927 - 10th Street - SACRAMENTO, CALIFORNIA 95814

LOCATION: 3019 E Street

PROPOSAL: Addition of three 800 square foot apartment units

~~DR84-172-~~
P84-337

NEW CARPORT & TRIPLEX ELEVATION

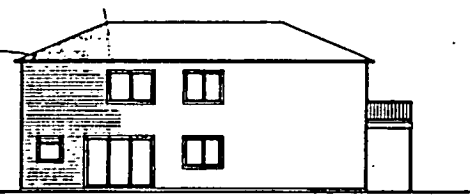
1. The doors on the exterior of the new construction should either be two or three-panel doors. The doors may be metal-clad and painted out to correspond with the rest of the building's trim.

2. The windows proposed for the new structure all appear to be sliders. Staff would suggest that either double-hung or single-hung windows would be more appropriate and in keeping with the overall design theme.

3. Sliding glass doors are proposed at the ground level and at the second-floor level of the new construction. If these were one of the better quality wood frame sliding doors, it would be more in keeping with the proposed architectural style.

4. The balusters and railings of the stairway and deck areas of the new structure should be of the same material, design and spacing as those to be provided on the existing structure.

1. All exterior doors, other than sliding glass doors, on the new construction shall be either two-panel or three-panel doors. The doors may be metal-clad.

2. All windows on the new construction should be either double-hung or single-hung, in wood construction or in pre-painted aluminum.
3. All balusters and railings on the new structure should be of a design similar to the new balusters and railings to be put on the existing building.
